2005 5TH AVE

02.17.2021

RESPONSE TO ARC MEETING

ARC 1 2017-08-30

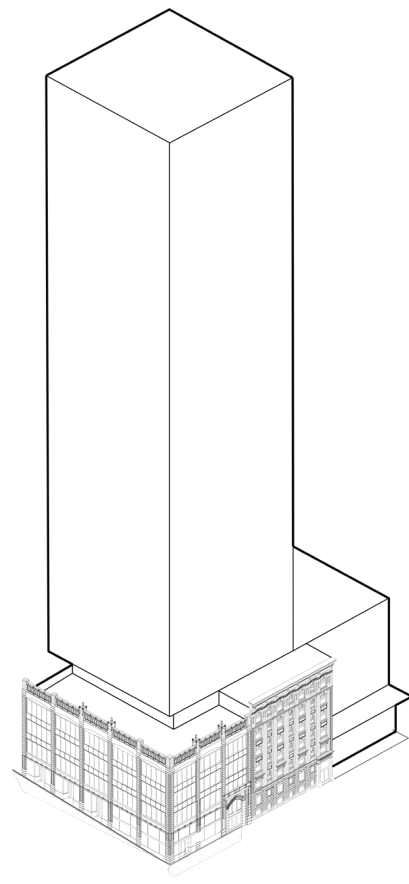
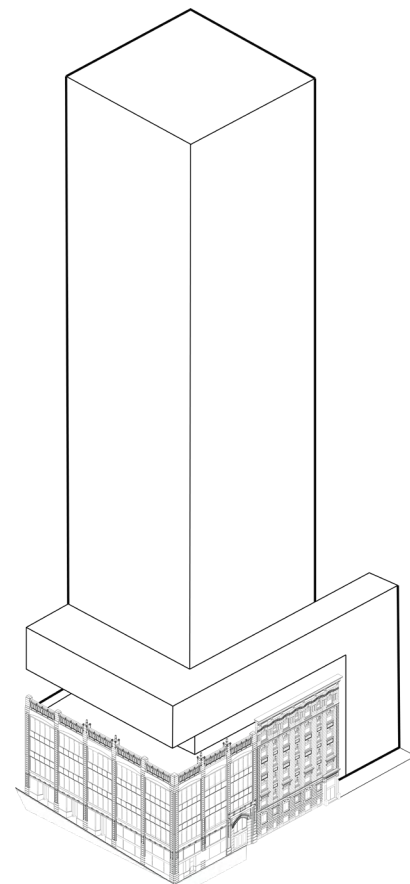
FINANCIAL FEASIBILITY ANALYSIS SHOULD BE
PROVIDED TO SUPPORT THE HEIGHT

ARC 2 2018-02-02

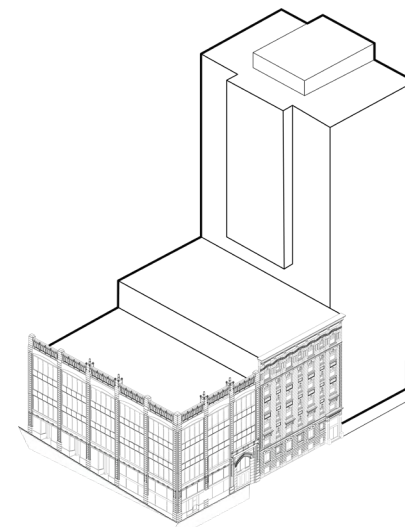
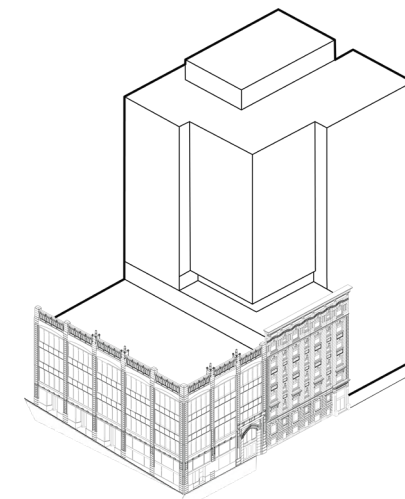
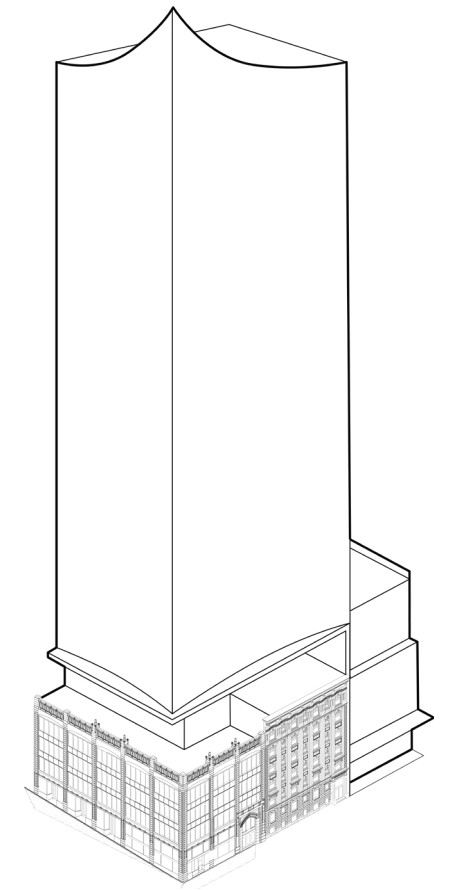
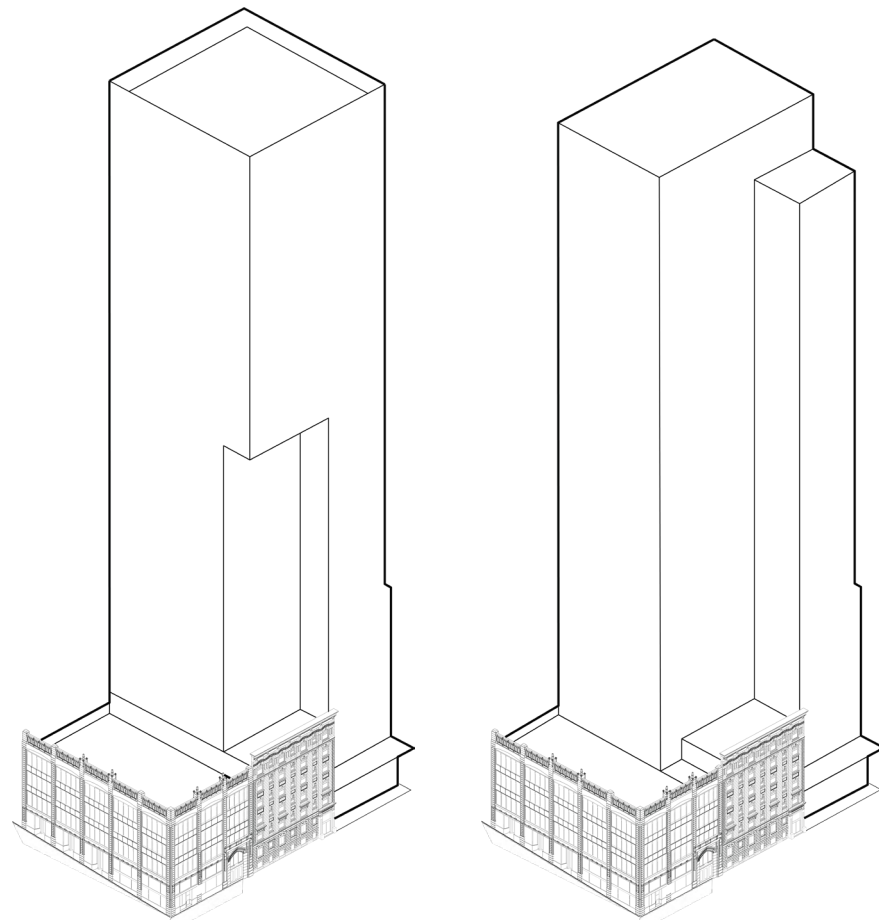
AGREEMENT THAT ALTERNATIVES ARE NOT
ECONOMICALLY FEASIBLE, BUT
TOWER LOCATION SHOULD BE OFF THE GRIFFIN

OPTION 7

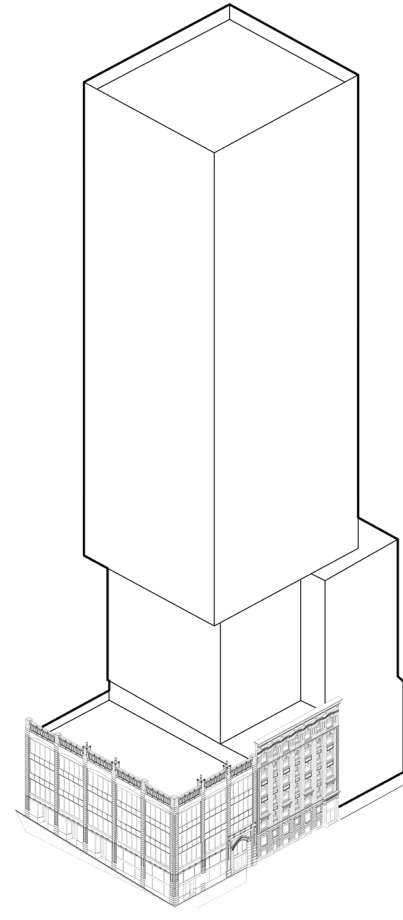
TOWER SPACING NEEDS
REFINEMENT;
PRESENT TO LPB

OPTION 8

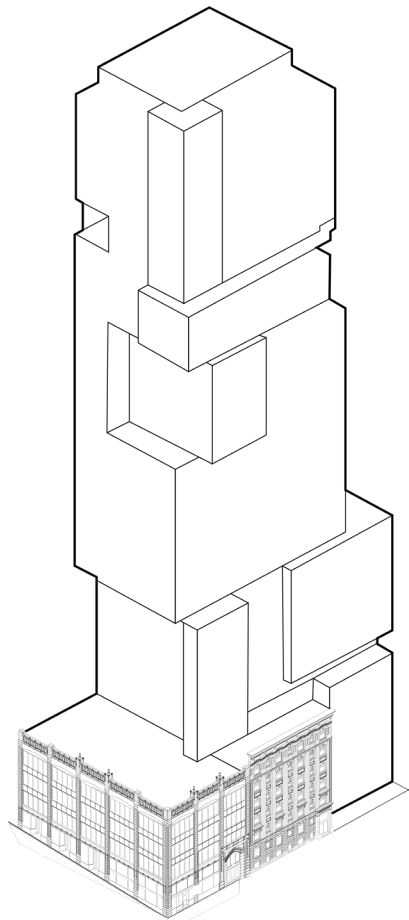
THE STEPPED EDGE IS NOT
WORKING IN THIS SITUATION.

OPTION 9

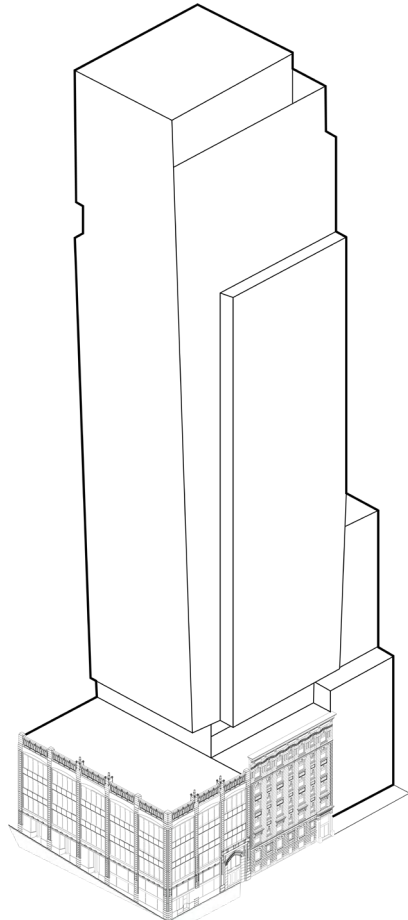
PREFERRED OPTION.
THE BOARD SUPPORTS THE 45'
TOWER SEPARATION ASSUMING THE
GRIFFIN BUILDING IS PRESERVED.

OPTION 10

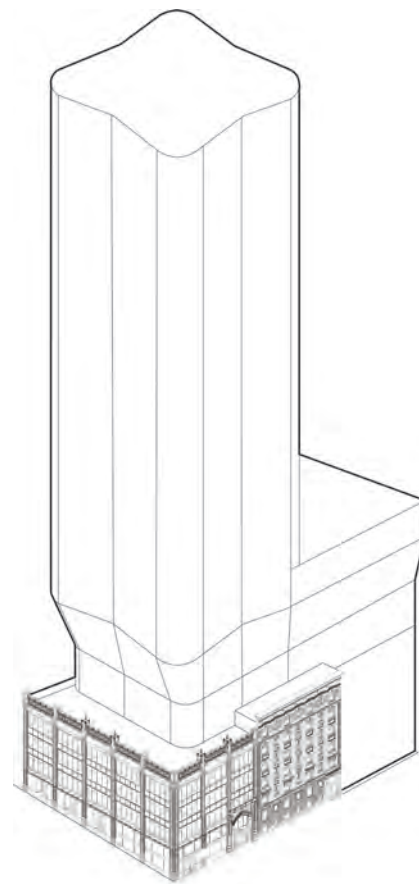
- APPRECIATED THE PROPOSED REHABILITATION OF THE LANDMARKS. NEW FORMALISM CONCEPT WAS WELL RECEIVED.
- APPROVED THE INTEGRATION OF BOTH LANDMARKS INTO THE DESIGN, INCLUDING UNDERGROUND PARKING BELOW GRIFFIN.
- APPRECIATED THE FUNCTION OF GRIFFIN AND SHERIDAN REMAINING AS OFFICE AND RESIDENTIAL RESPECTIVELY.
- SUGGESTED STUDYING AN OPTION WITHOUT THE TAPER.
- REQUESTED IMAGERY WITHOUT CLOUDS AND SUN OBSCURING THE DESIGN.
